Subject:
 RE: SES-MOD-20210125-00436; Call Sign: E050340

Subject: SES-MOD-20210125-00436; Call Sign: E050340

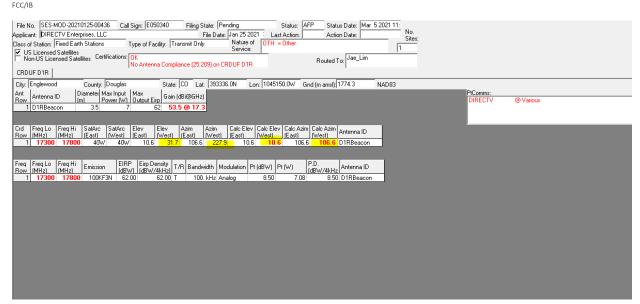
We are working on your MOD and would like to confirm with you to change elev W and Azim W as you see below.

Good afternoon, Jae; thank you for your email. It looks like you may be using a value for SatArc (West) of 40W instead of the 140W value that we included in the application. If you change that value to 140W, I believe the calculated Elev (West) and Azim (West) values should match the Elev (West) and Azim (West) values that we included in the application. Please let me know if you have any additional questions or if we can provide you with any additional information.
